**Compton Community College District
Geotechnical and Soils Investigation Report
For
Campus Public Safety Building**

- 1. Original Report Prepared by GeoTek, Inc. dated October 24, 2016**
- 2. Supplemental Geotechnical Report and Evaluation regarding over-excavation requirements dated January 16, 2017 prepared by United-Heider Inspection Group**
- 3. DSA form 109 Transfer of Responsibility: Geotechnical Engineer from GeoTek to United-Heider Inspection Group dated January 27, 2016**
- 4. CGS First review letter dated January 30, 2017**
- 5. United-Heider Response to CGS first review letter dated April 5, 2017**
- 6. CGS Second review letter dated May 1, 2017**
- 7. United-Heider Response to CGS second review letter dated June 2, 2017**
- 8. CGS Third review letter and approval dated June 14, 2017**

Subject: Response to CGS January 30, 2017 Review Letter
Compton Community College – Public Safety Building
1111 East Artesia Boulevard, Compton, California 90221
United-Heider Project# 10-17036PW

Subject: Response to Second CGS Review Letter
Compton Community College – Public Safety Building
1111 East Artesia Boulevard, Compton, California 90221
United-Heider Project# 10-17036PW

Compton Center - Public Safety Building 1111 E. Artesia Blvd Compton, California	United-Heider #10-17036-PW	March 2017
	Flood Hazard Map	Figure 6

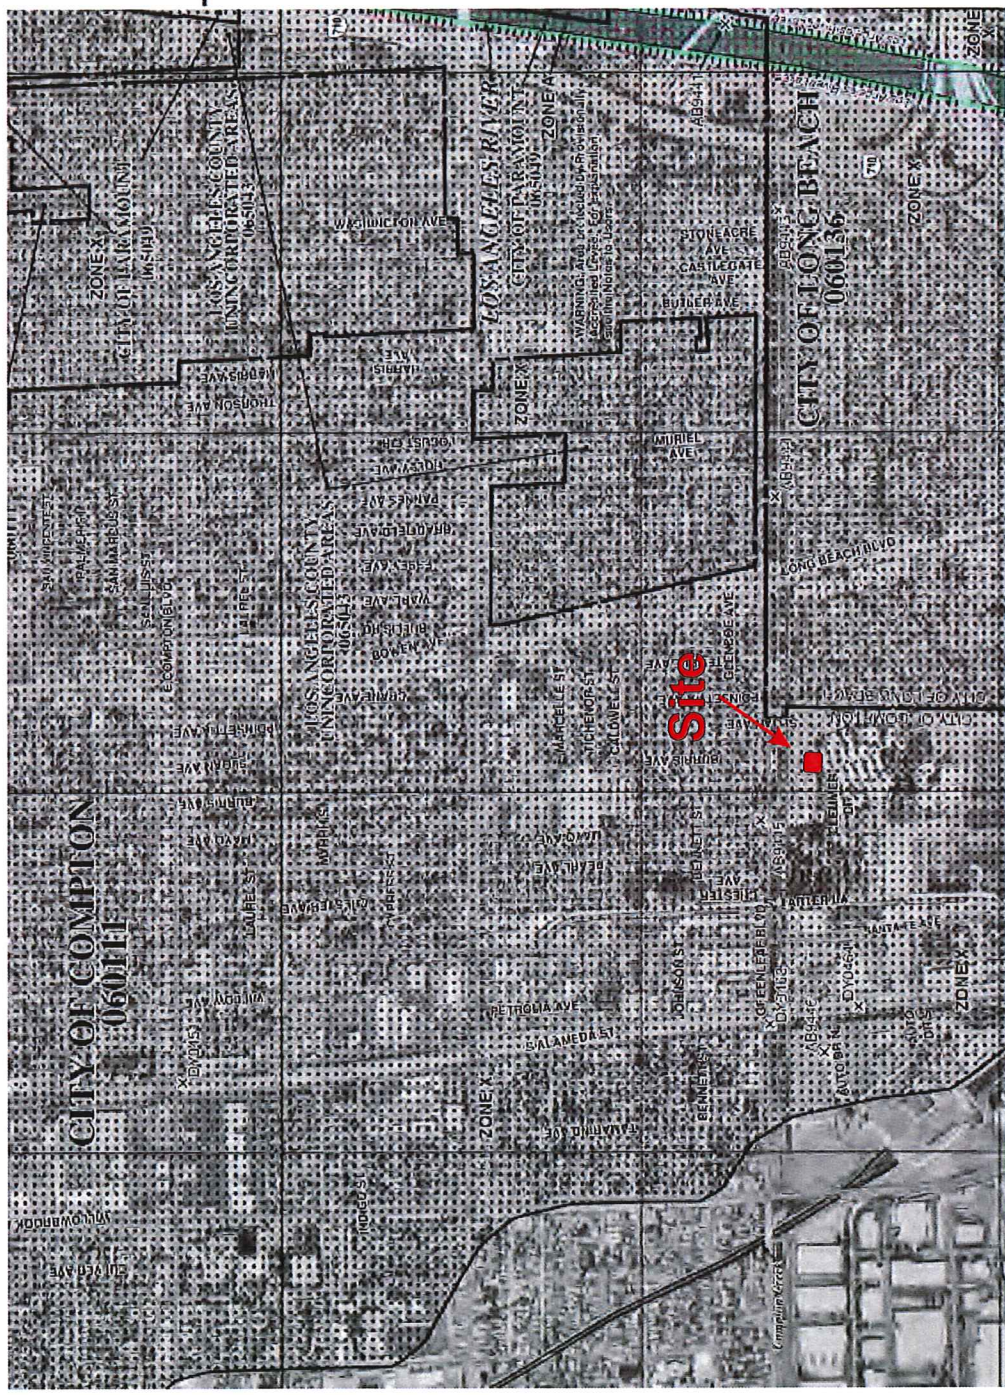
Comment, Note 48, #31-C:

Flooding: We evaluated the project site which did not appear to be subject to significant flooding. As shown on the attached *Figure 6, Flood Hazard Map*, FEMA (2008) has mapped the proposed building location as within Zone X (dot); i.e., a flood-hazard area which is within the area of 0.2% annual chance floodplain, areas of one percent annual chance flood with average depths of less than one foot or with drainage areas less than one square mile. Therefore, the site is considered to have a relatively low hazard of significant flooding. An in-depth engineering evaluation of the flooding potential of the site is beyond the scope of this study or our expertise, and a flood specialist should be contacted if a more in-depth flooding analysis is desired.

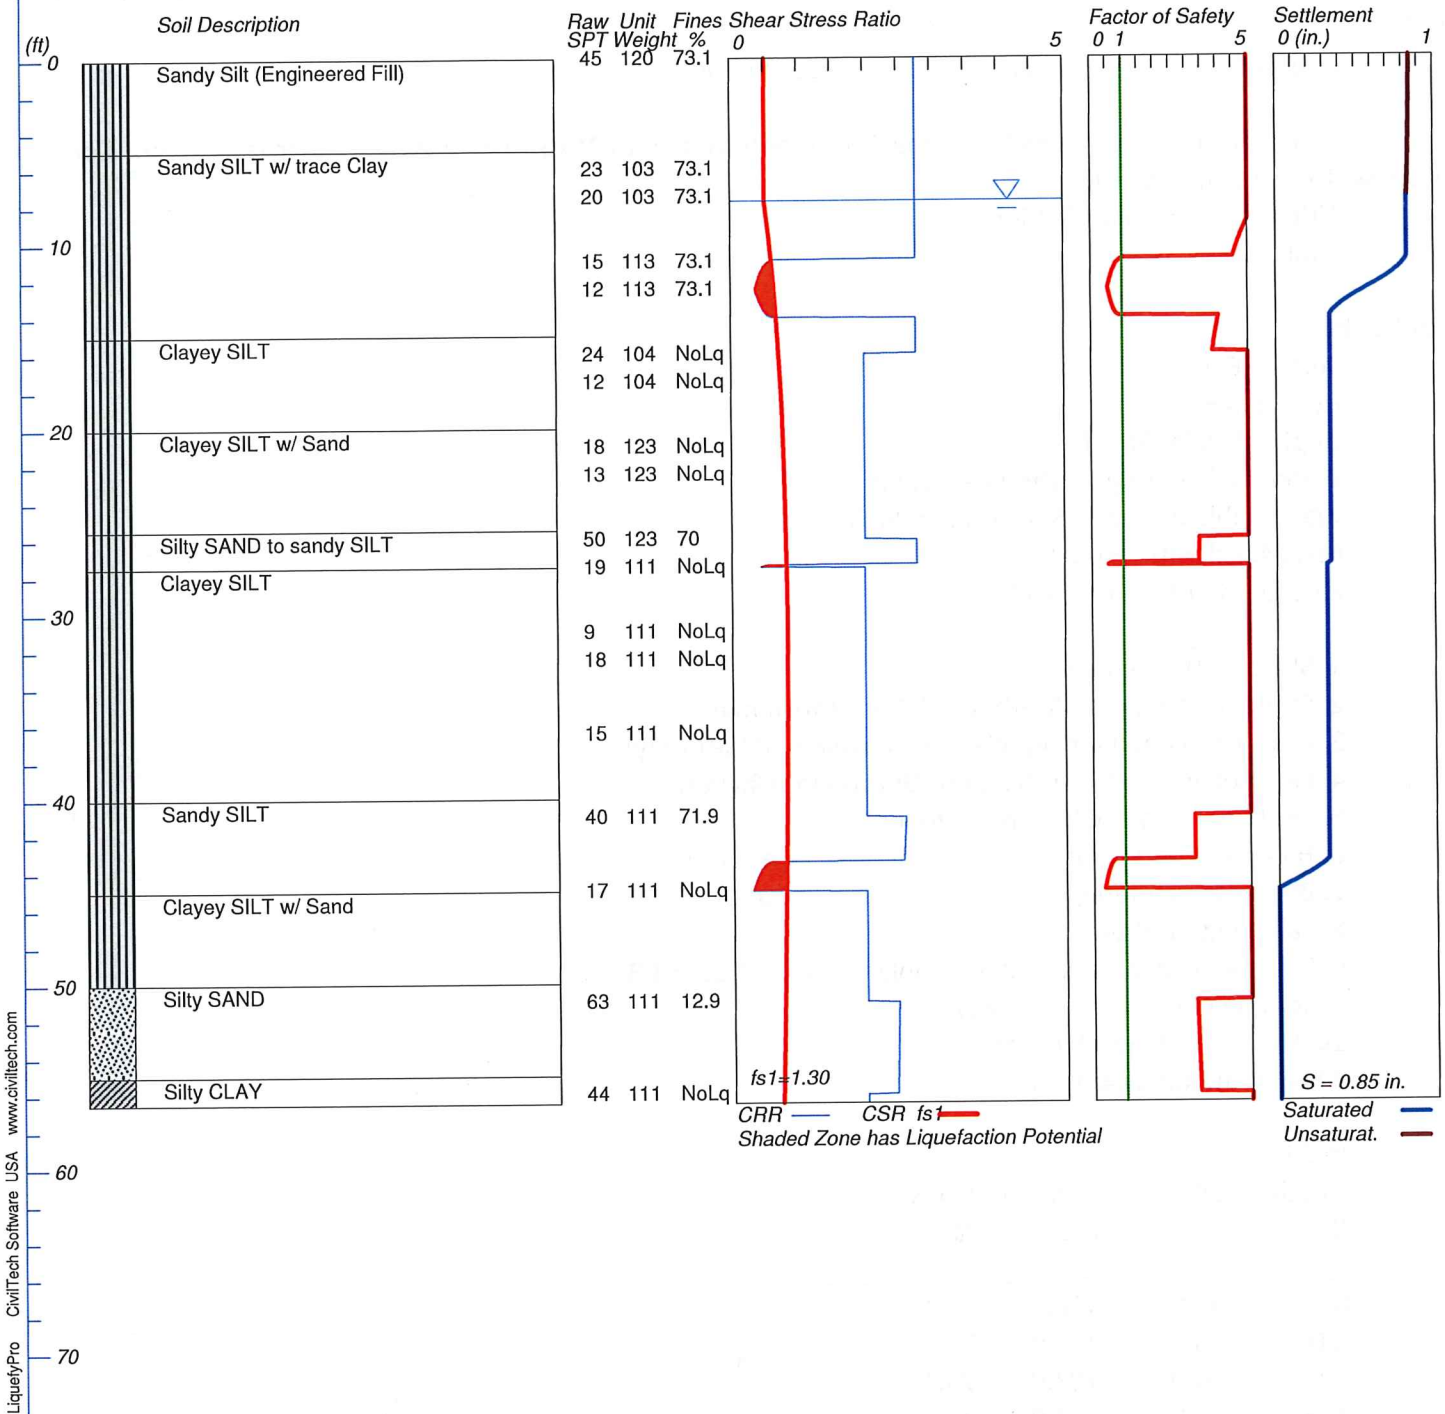
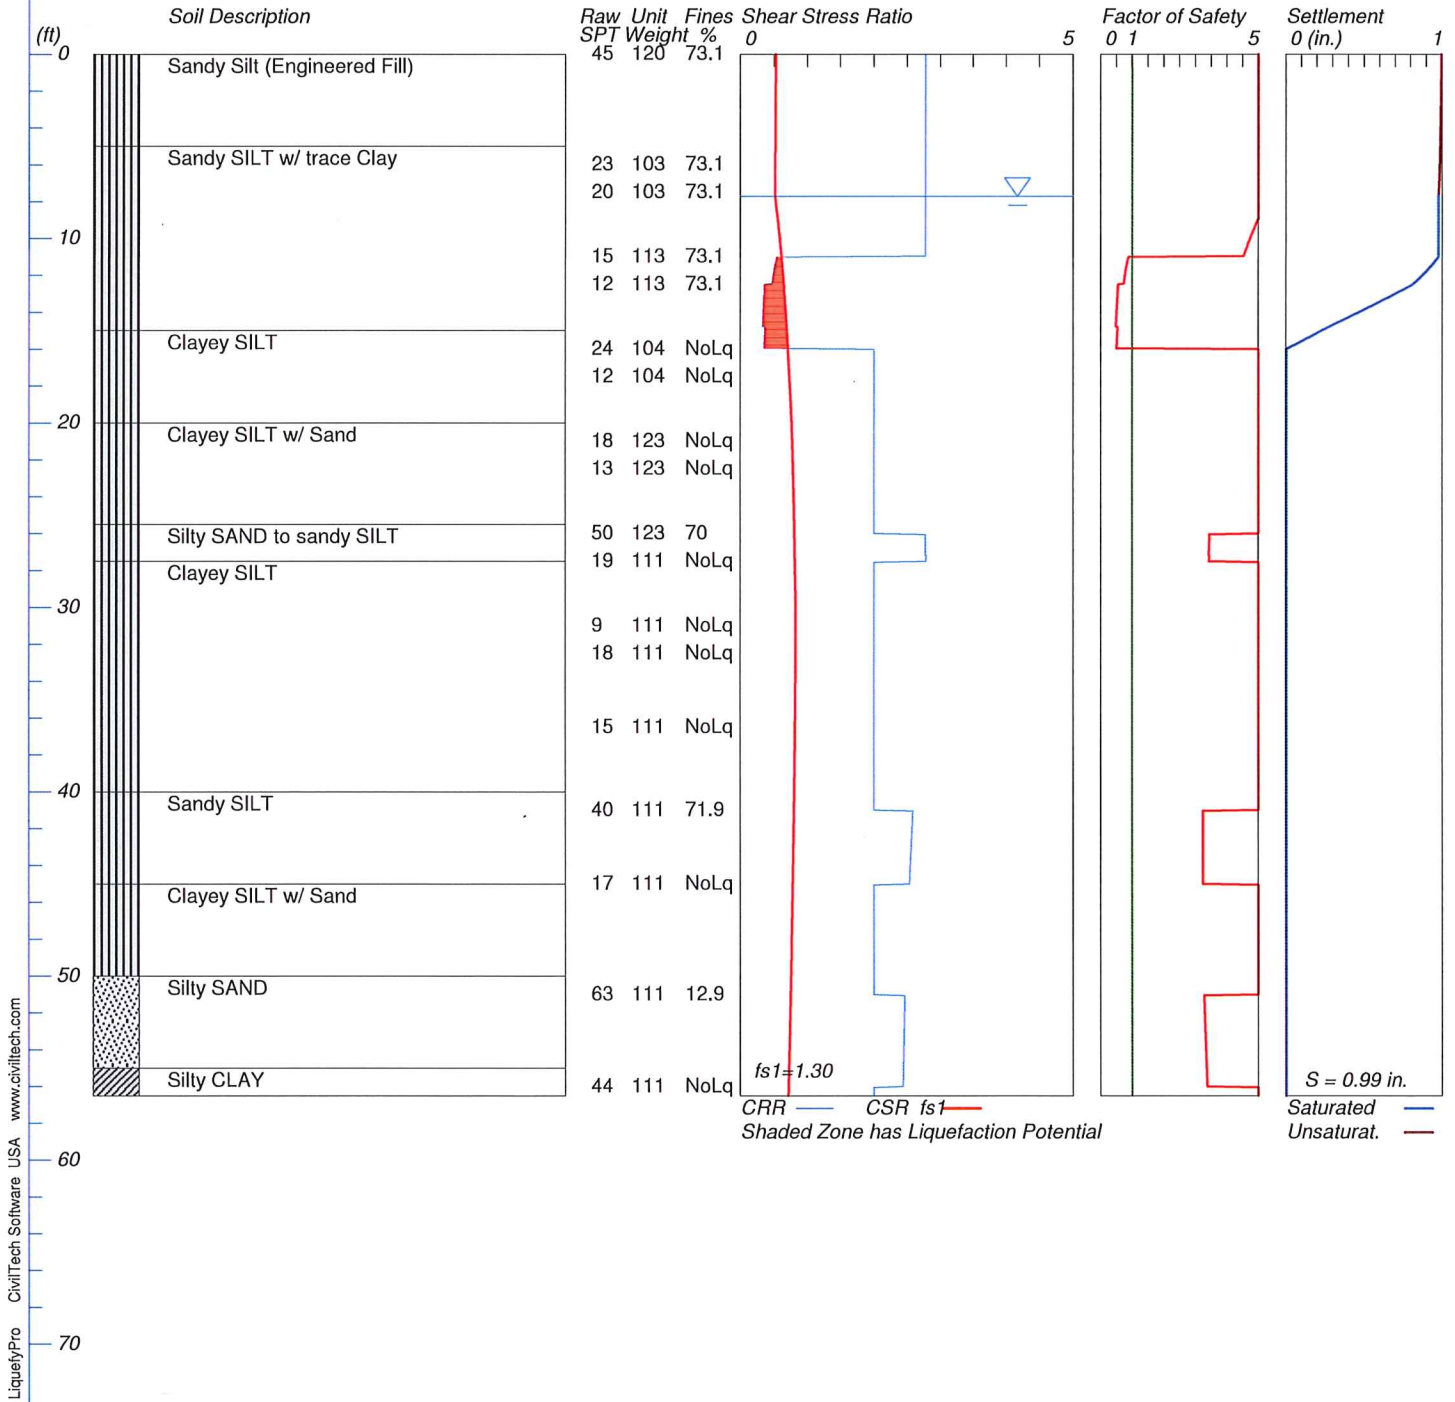
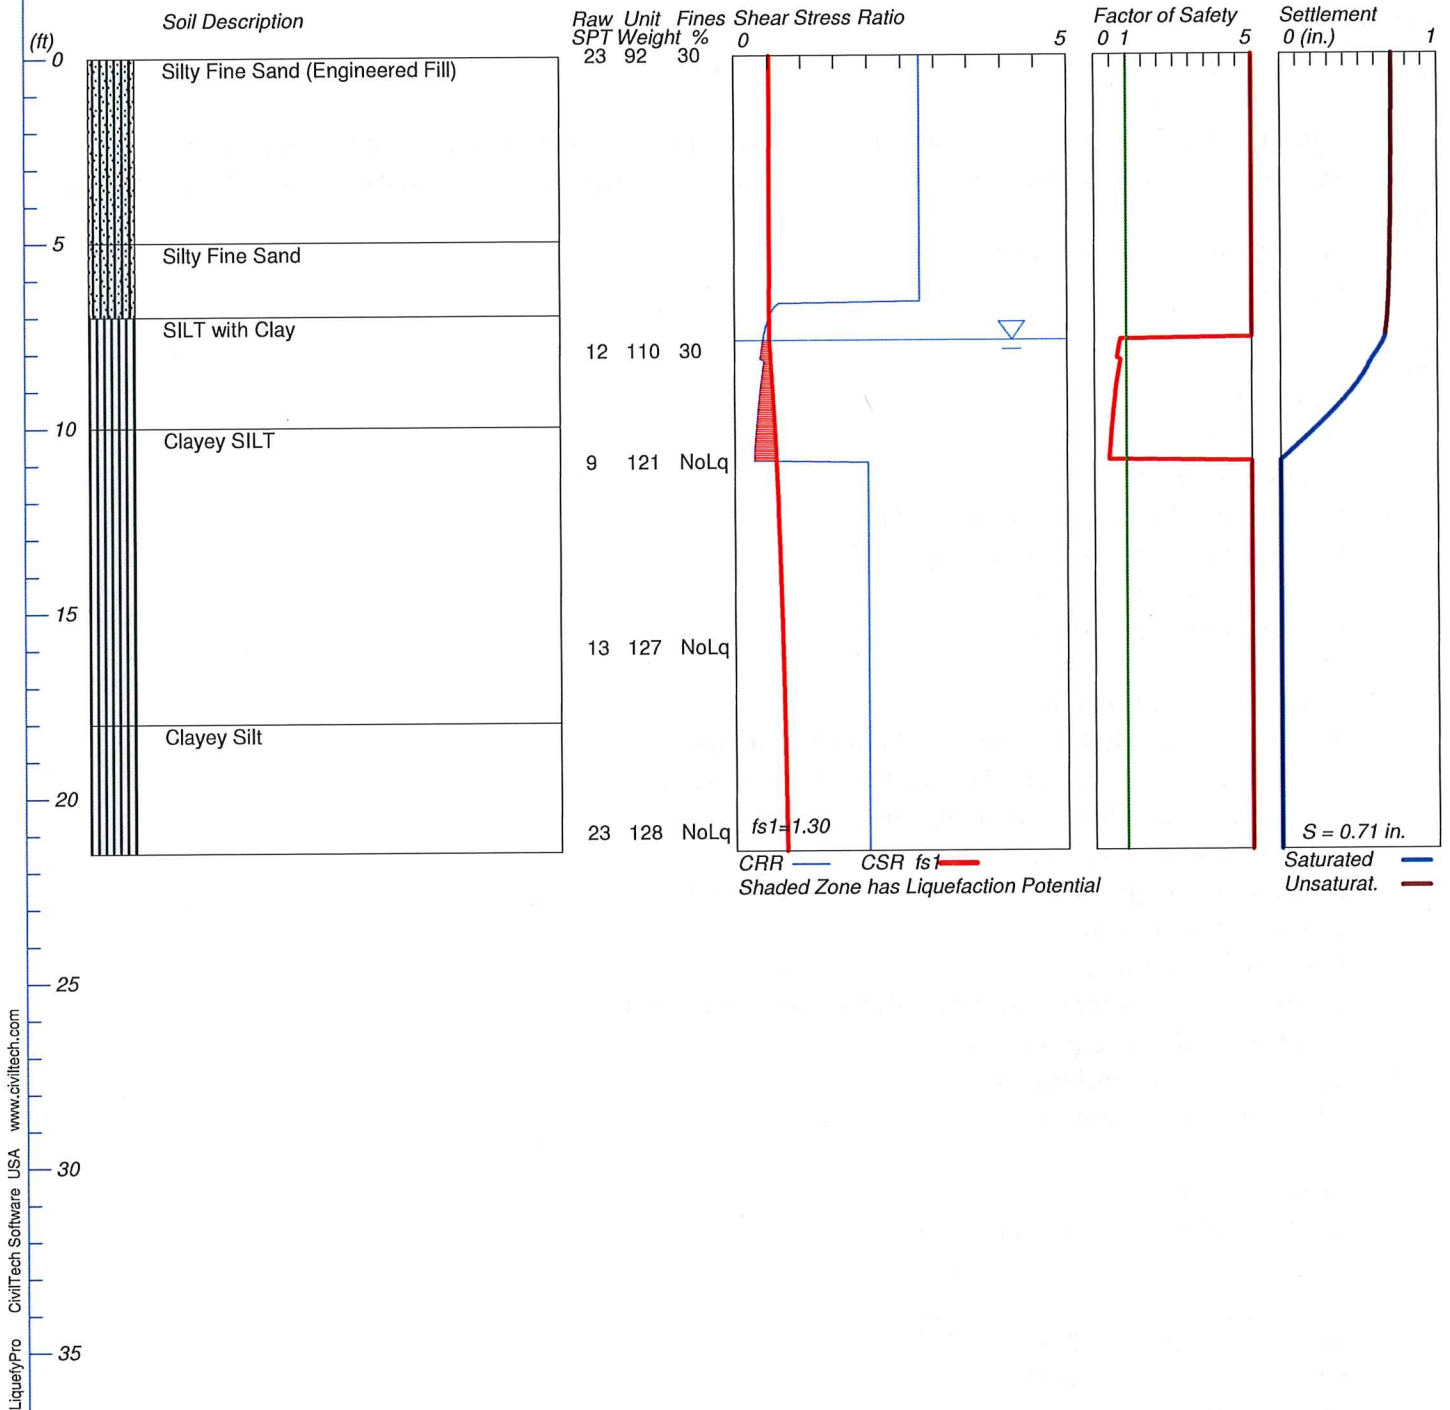
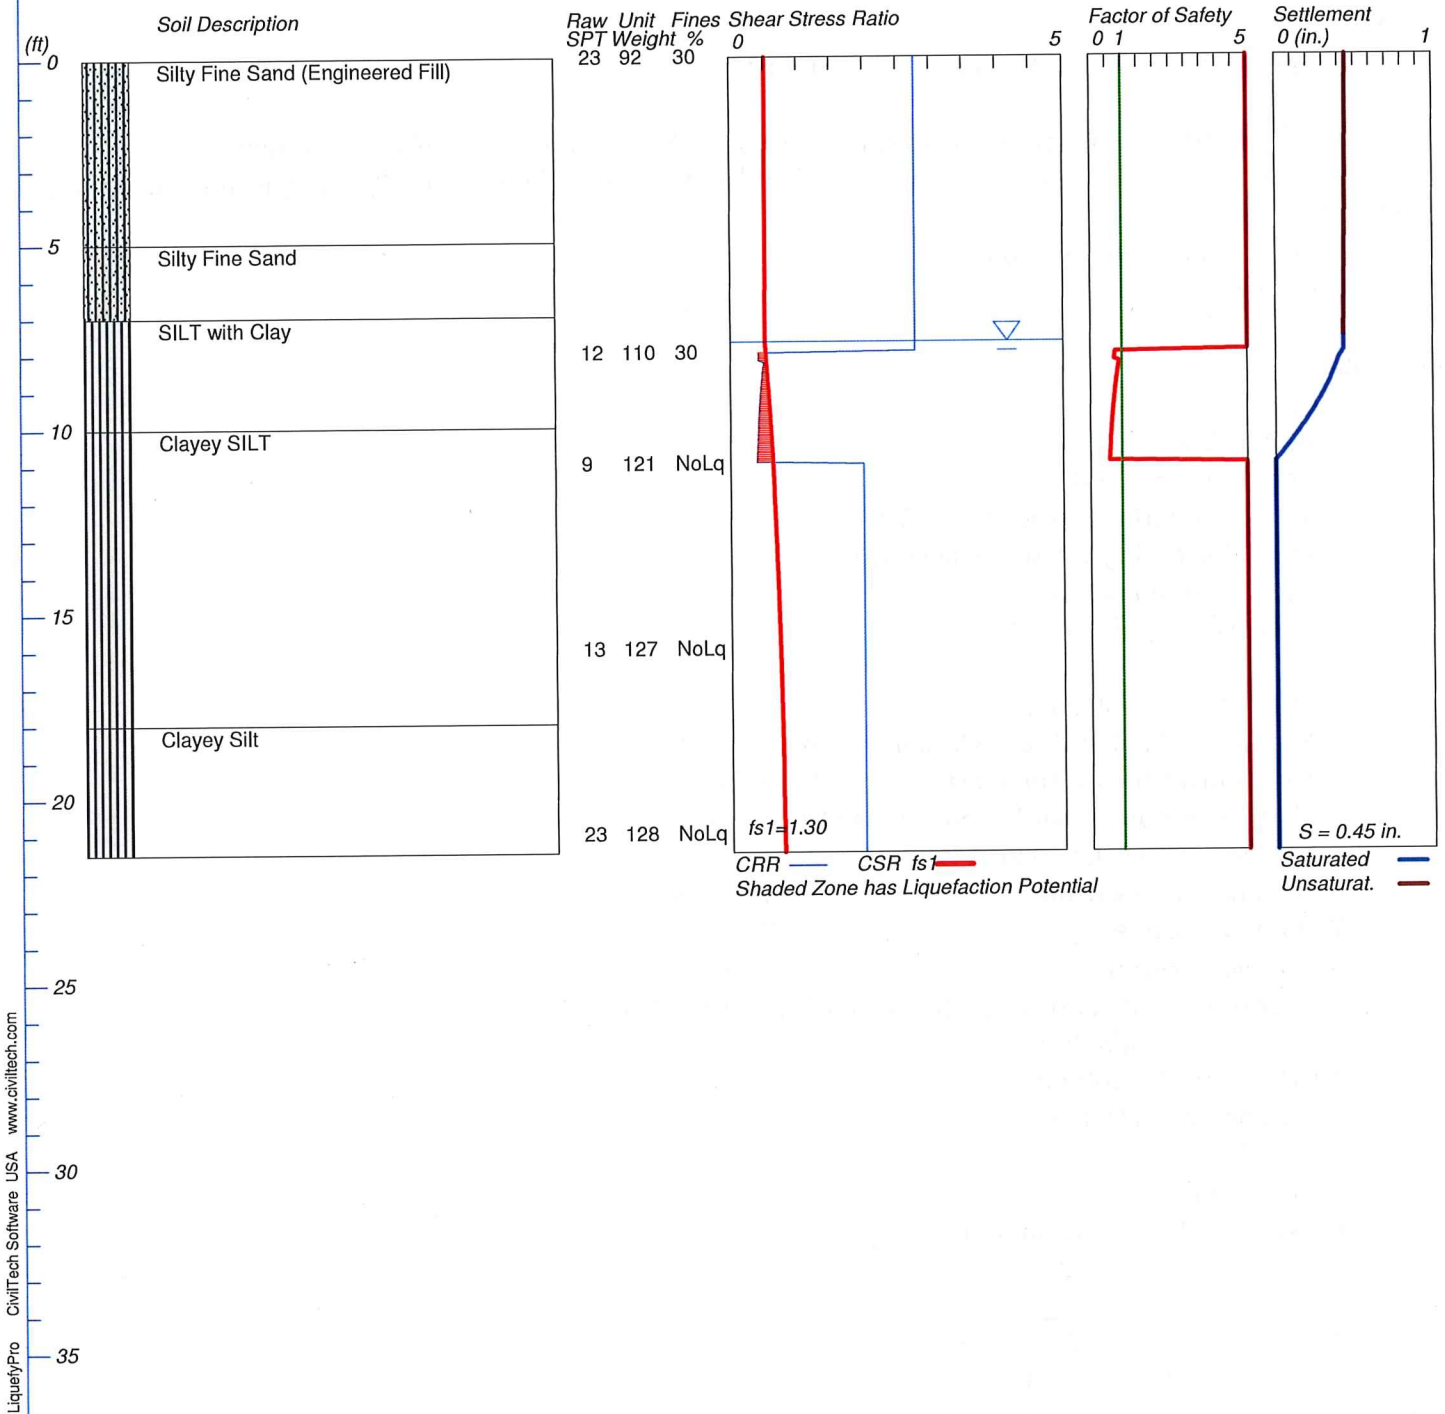
Comment, Note 48 #20:

in details and additional findings from the project site we have reviewed the liquefaction analysis using corrected input parameters. As recommended in the original geotechnical report, removal and replacement of 15 feet of fills is voided. In our calculations, any stiff silt containing 14.4% and higher clay with Plasticity Index of 10 or higher has been considered non-liquefiable soils. We also noticed that the blow counts are supposed to be 9 (corrected blow count) instead of 18 which we revised on our revised liquefaction analyses. We received the hammer efficiency calibration chart for the hammer we used for the sampling performed by SPT Cal, dated March 19, 2016. The average efficiency of the hammer calibrated for depths from 30 to 50 feet was 84.1 percent. Therefore, we used a C_E value of 1.25 as a safe factor in our calculation. Other factors such as borehole diameter (C_b) and sampling method (C_s) were picked as 1.15 and 1.2, respectively. A factor-of-safety of 1.3 was used.

In addition to these factors, we re-evaluated the seismic parameters used for liquefaction analysis. Based on our revised parameters, a Peak Ground Acceleration (PGA) of still 0.62g is applicable. However, Moment Magnitude (M) to cause this peak acceleration was found to be 6.6M which is evident from Probabilistic Seismic Hazard Deaggregation on NEHRP Site Class D; see attached Deaggregation figure for PGA. Using these parameters as input, we performed a liquefaction analysis on Boring B-1 using the Liquefy-Pro V5.5b developed by CivilTech Software. Based on the liquefaction analysis calculated results, total estimated vertical settlement of 0.96 inches and differential settlements from 0.48 to 0.63 inches were obtained.

potential liquefiable layer is 3.2, which indicates that a potential for surface manifestation is unlikely. For detail thickness analysis, please refer to graphical liquefaction analysis results attached.
